PROPOSED AMENDMENT TO THE YONKERS DOWNTOWN WATERFRONT PLAN, SEPTEMBER 1997, MAY 1998

JULY 2007 PROPOSED AMMENDED
 SEPTEMBER 1997 EHRENKRANTZ ECKSTUT & KUHN ARCHITECTS

FIGURE 21: MAXIMUM BUILDING HEIGHTS

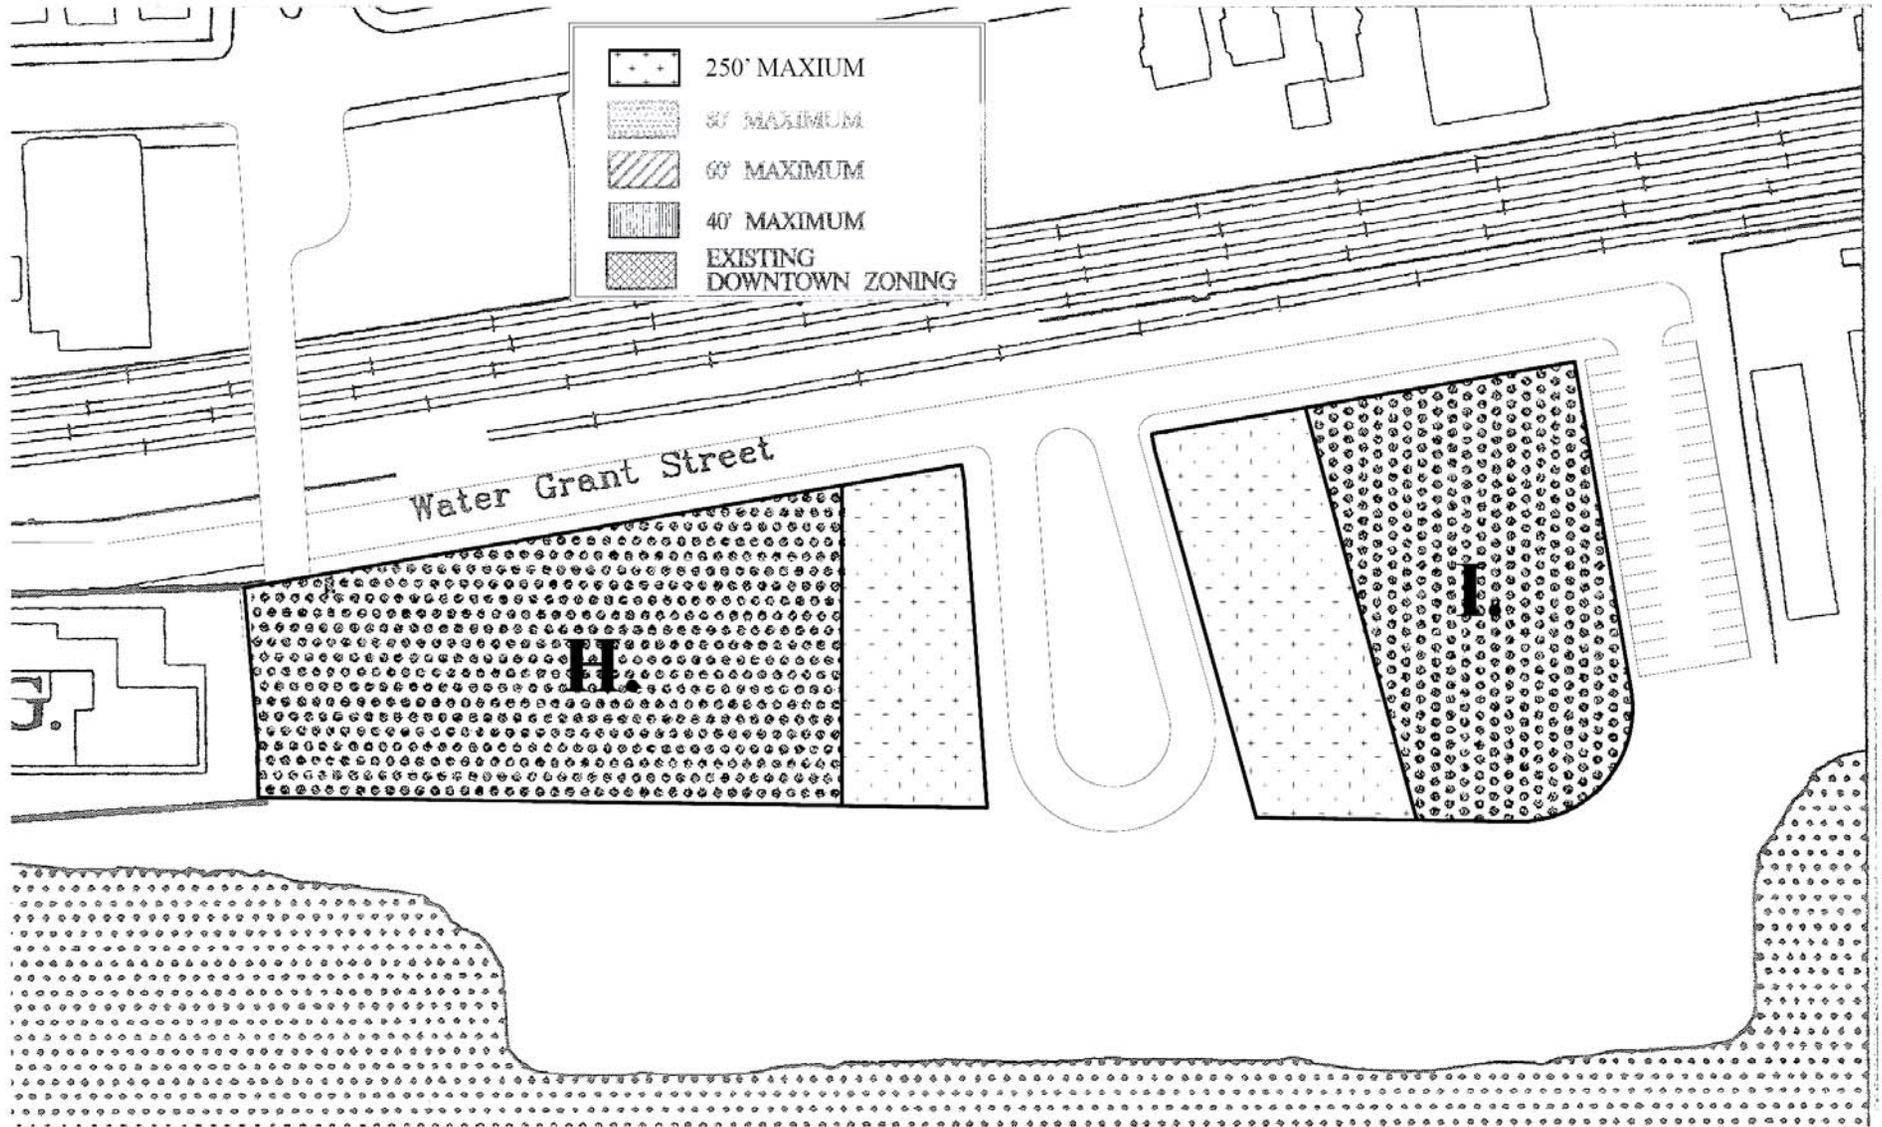
Second sentence of the first paragraph on Page 33 is amended to read: “Building heights will vary, but can reach a height of 25 stories if view corridors are maintained and publicly accessible open space is provided. See Figure 21.”

Figure 21 is amended to reflect 25-story buildings proposed at Palisades Point.
